ADDENDUM NO. 4

Date: September 25, 2023

Project Name: Traffic Operations Facility, IRC-2104

Bid Number: **2023059**

ROOF PLAN

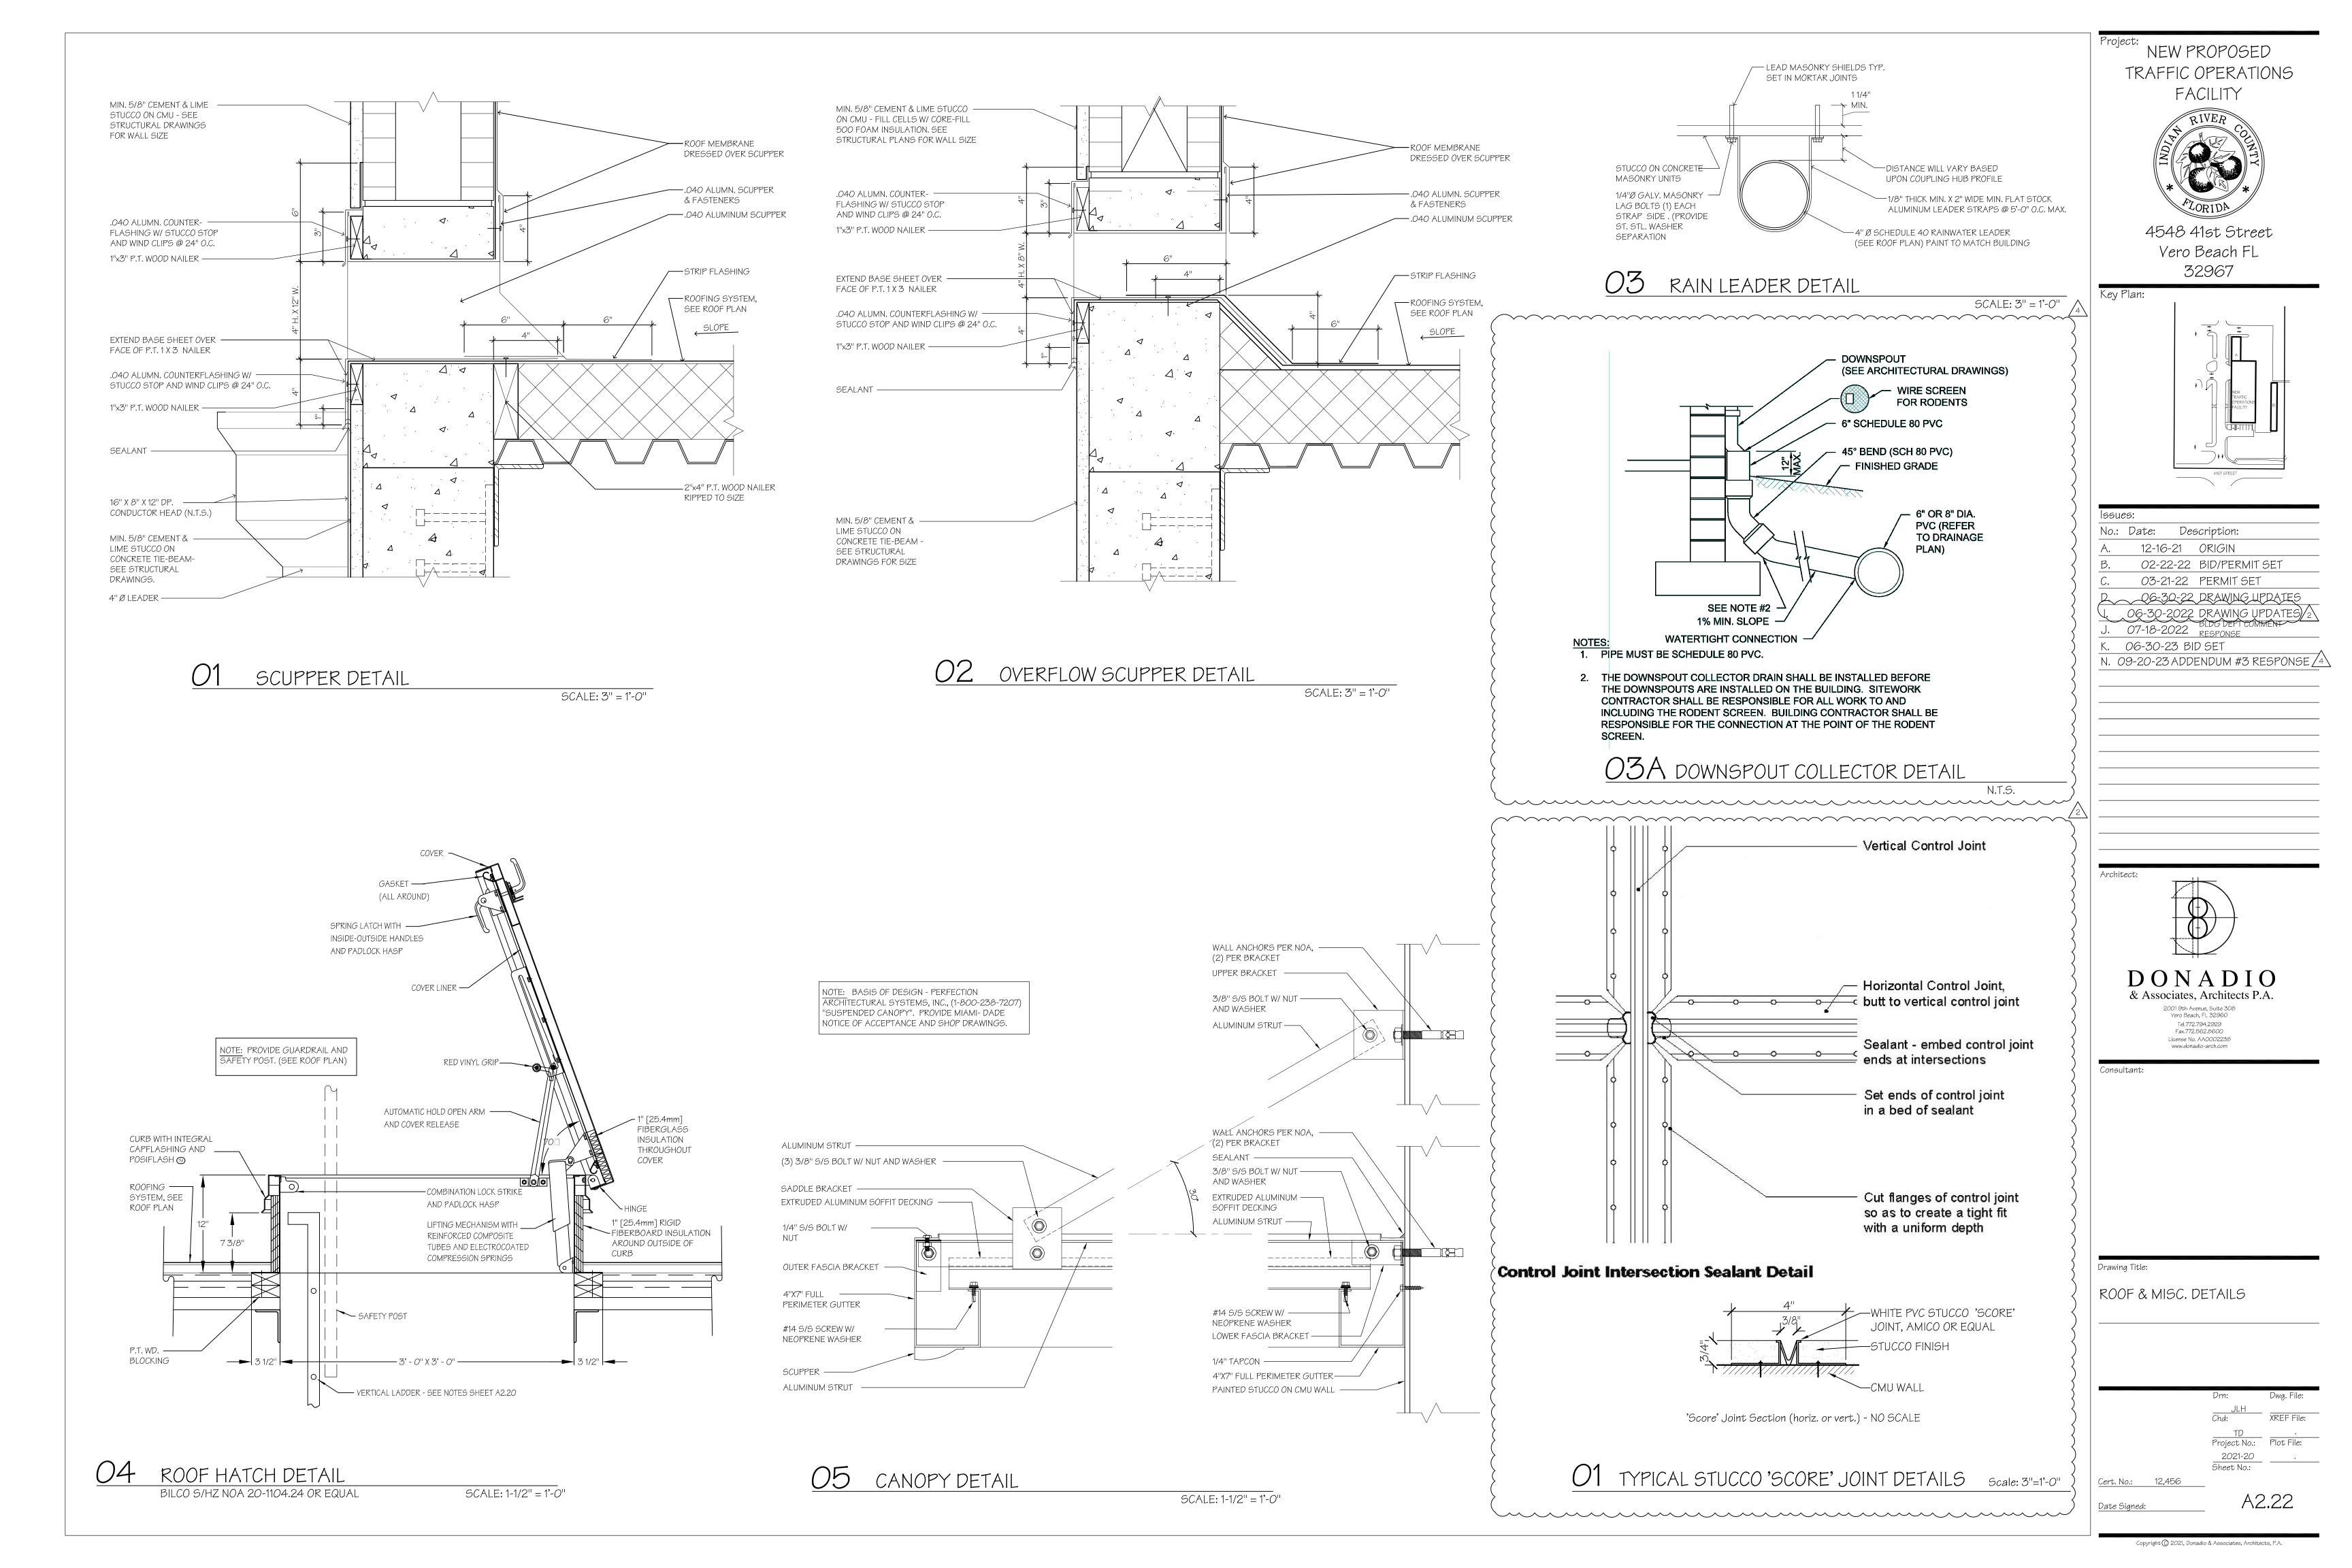
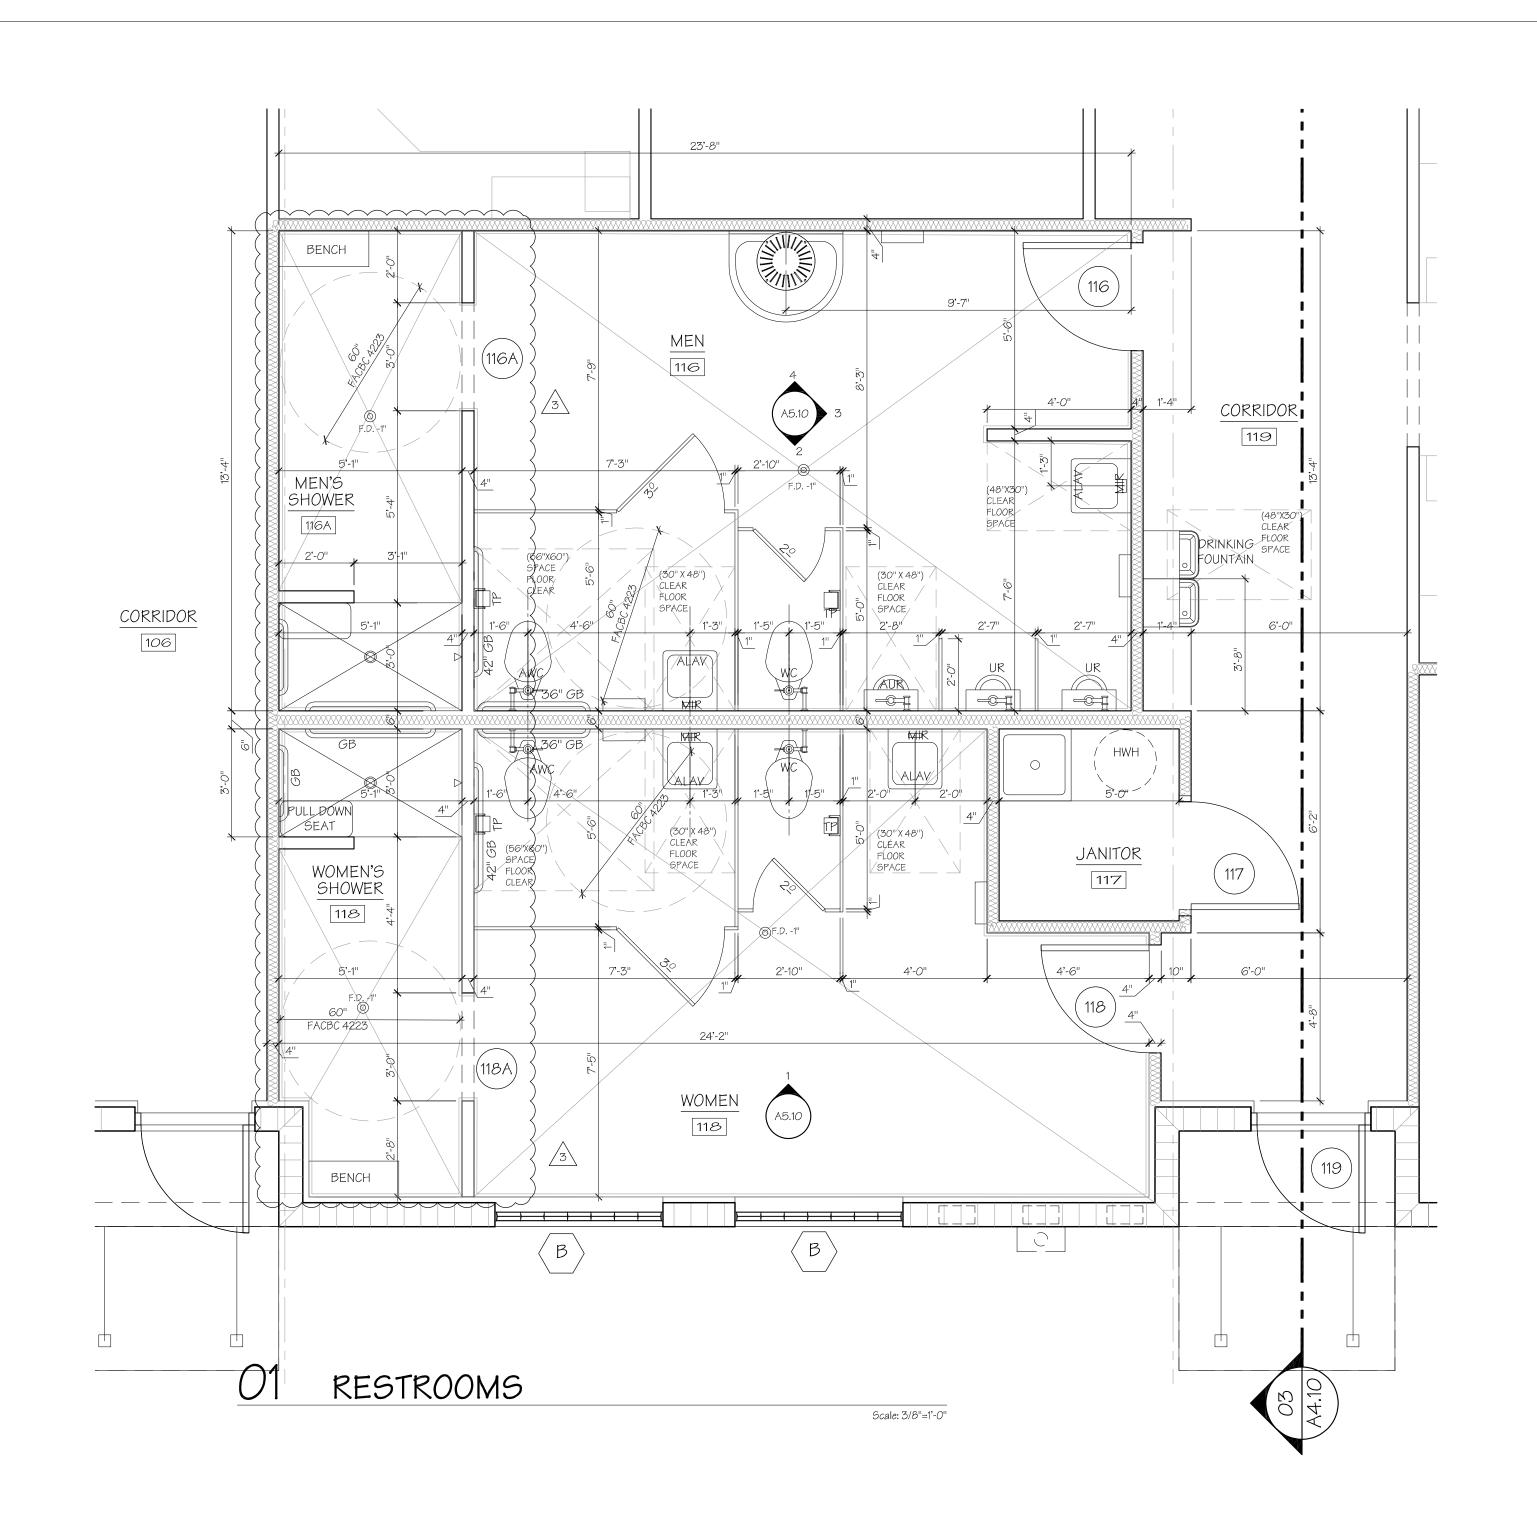
- Question 33. Drawing A2.20 indicates 3" rigid insulation with an R Value of R-20. A 3" thick rigid board will provide 17.4 R value. In order to get an R-20 value the thickness would need to be 3.5" thick. Please clarify thickness and R-value for roof insulation.

- Answer 34. Per Specification SECTION 07551 2.7E and Section 3.3I cover board is required on top of the insulation board.
- Question 35. Note 1 on drawing A2.20 indicate the conductor head boxes to be 12"x8"x12". Detail on A2.22 indicates the conductor head boxes to be 16"x8"x12". Please clarify dimensions of conductor head box

- Answer 33. Rigid Insulation for Transportation Building to be 3.5" thick with R- value of 20. See revised drawing Sheet A2.20.
- Question 34. Specification 07551 Section 2.7E and Section 3.3I mention a cover board for the 3-Ply modified bitumen roofing system. Roofing details on A2.22 do not indicate a cover board. Please clarify if a cover board is required on top of the insulation.

- Answer 35. Conductor Head Boxes to be 16" x 8" x 12" per Detail 01 on A2.22. Note 1 revised on Sheet A2.20.
- Question 36. Detail 3 on A2.22 indicates the rainwater leaders to be Schedule 40 which is assumed to be PVC. Specification07710 Section 2.3 indicates the downspouts to be aluminum. Please confirm material of downspouts.

Drawing Title: ROOM FINISH SCHEDULE

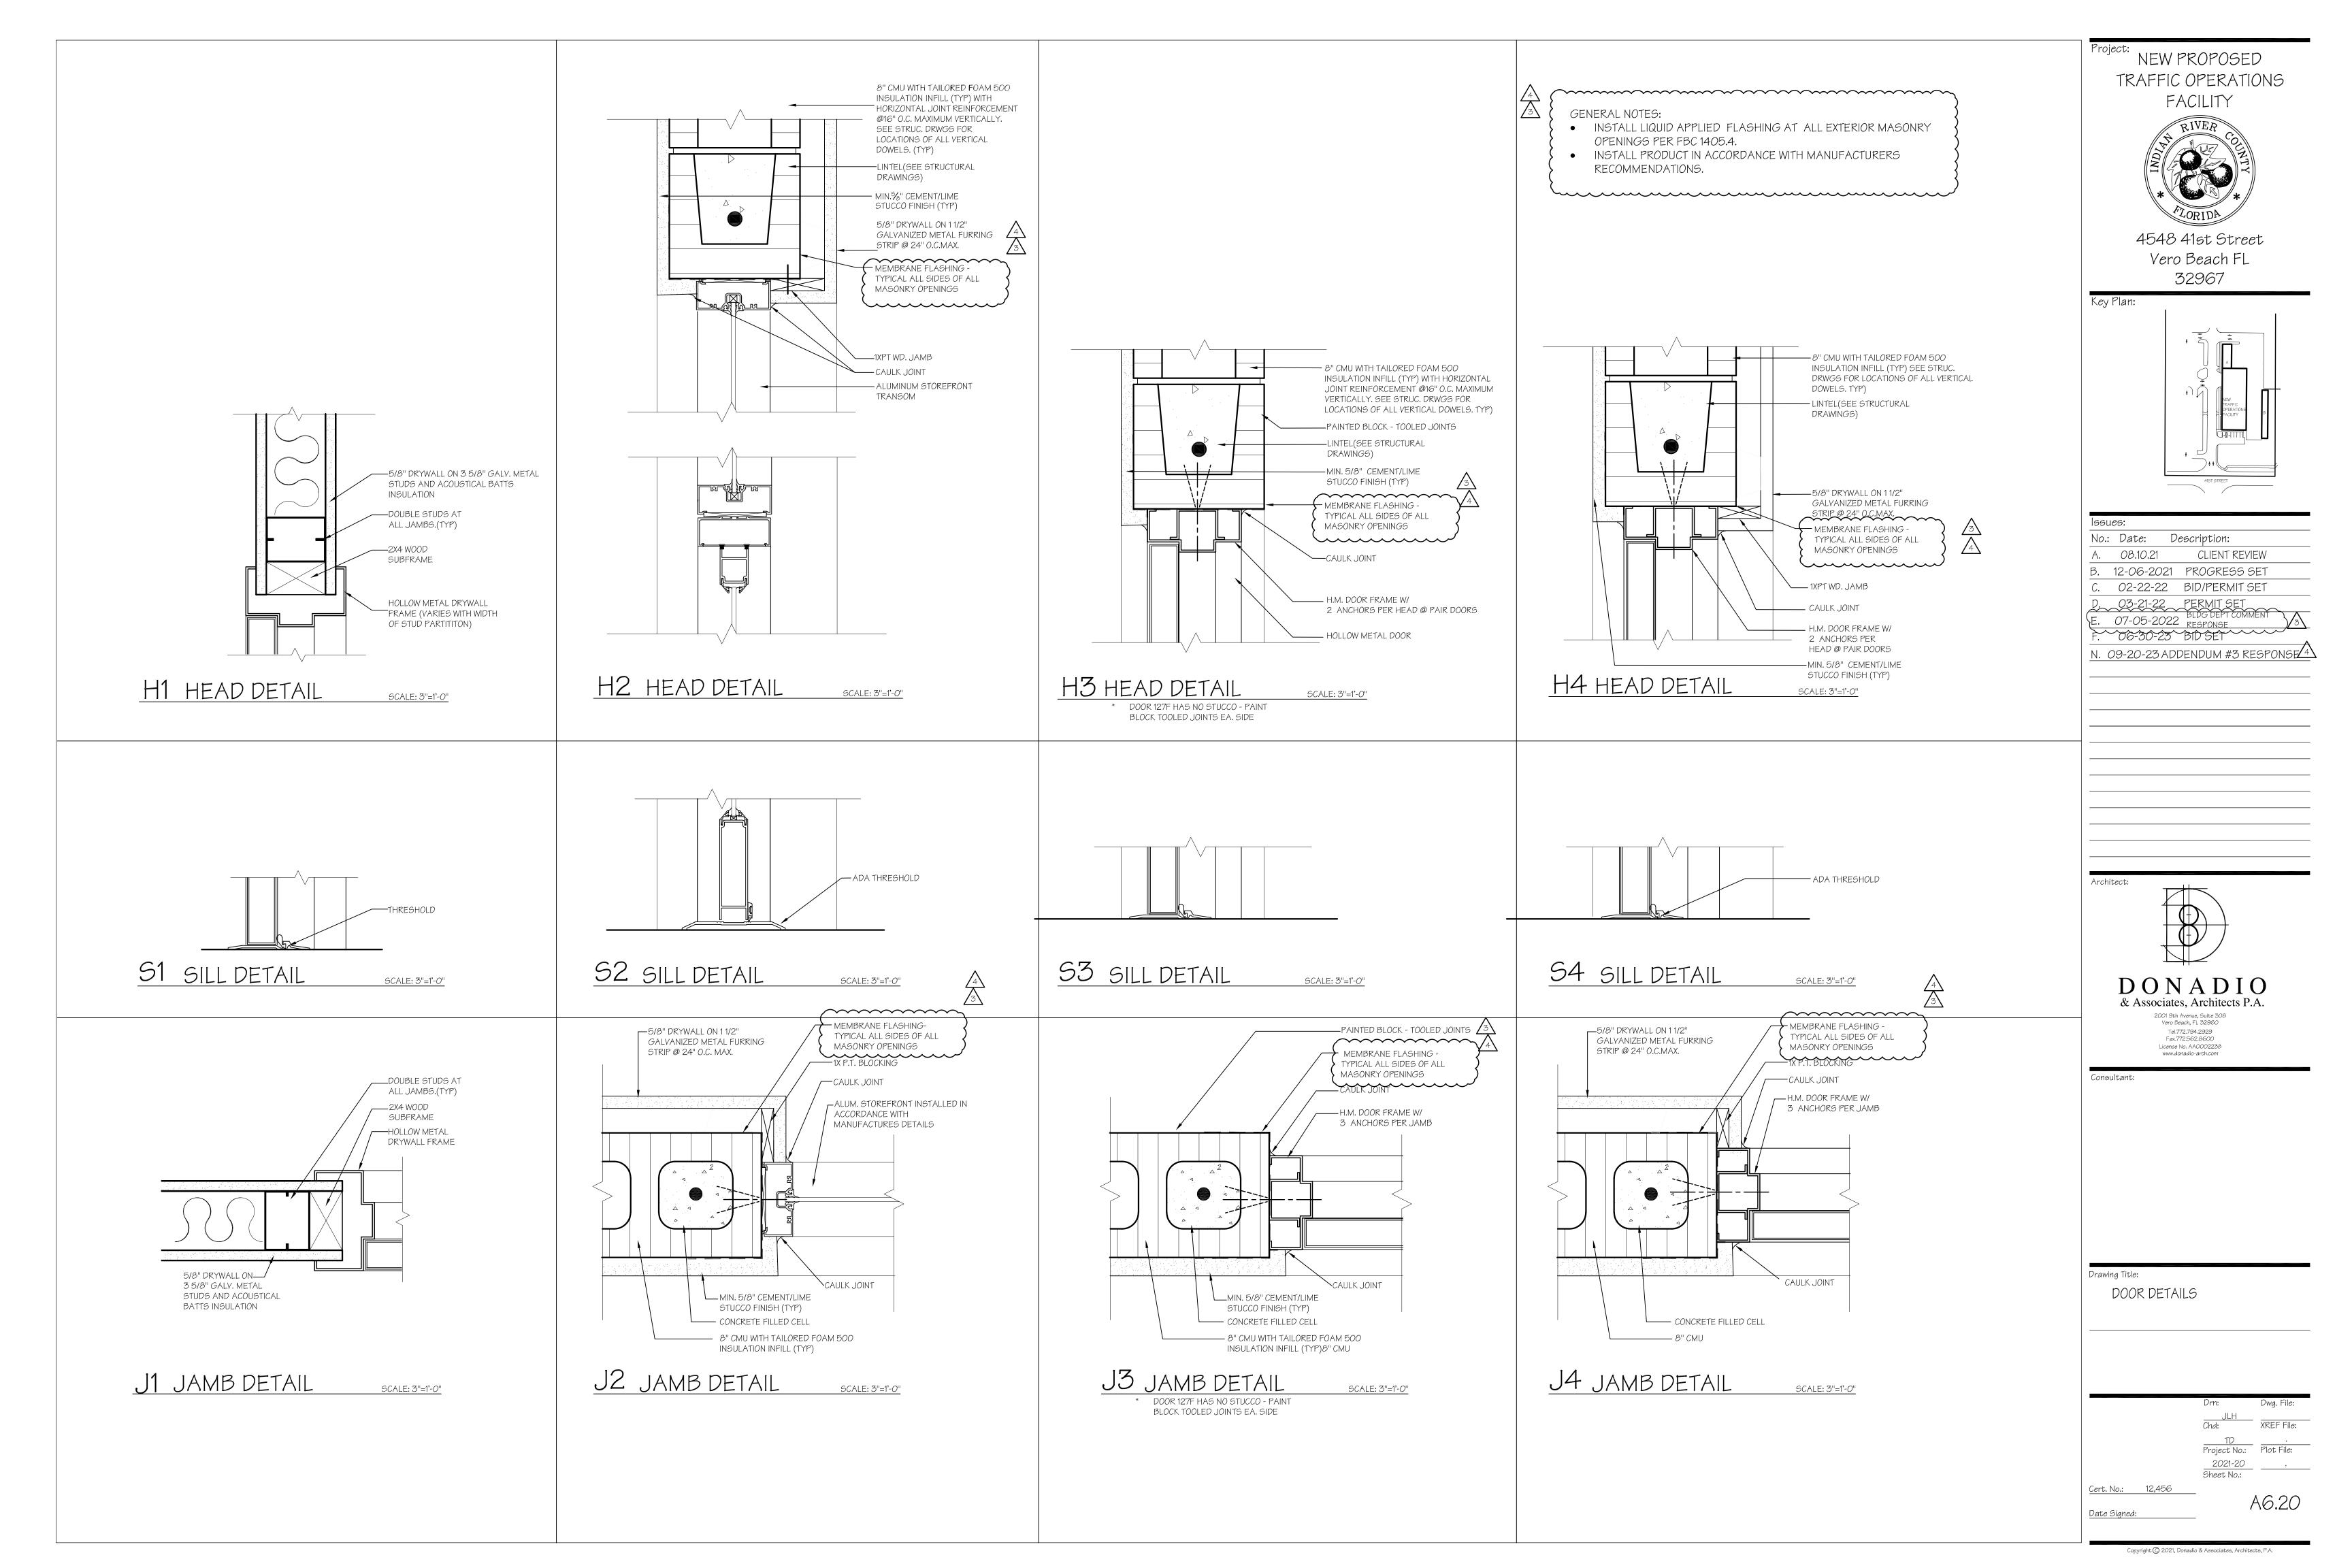
- Answer 42. Drawing A2.10 Construction Legend has been Revised. 1 Hour Rated Assembly is not applicable.
- Question 43. Please confirm there is no stucco on masonry walls at Warehouse 125 and 126 as shown on A2.10. Please confirm there is no stucco nor furring and drywall on masonry walls at Sign Shop 120 and Signal Shop124 as shown on A2.10.

- Answer 43. See Finish Schedule Sheet A6.11, Rooms 120, 124 125, 126: CMU walls where called out are listed to have tooled joints and painted finish.
- Question 44. Please clarify if the exposed steel and metal deck at Signal Shop 124 and Mechanical 123 need to be spray painted.

- Answer 44. See Sheet A6.11 Finish Schedule. Exposed steel and metal deck at Signal Shop 124 & Mechanical Room 123 are listed to be painted. Exposed steel and metal deck to be spray painted.

Drawing A1.10.Please provide quantity of capacity signs if applicable to project.
- Answer 53. See Revised Sheet A6.11 Sign List for Capacity Sign for Break Room 104: Max. Occupancy 46. Also see Question 11.
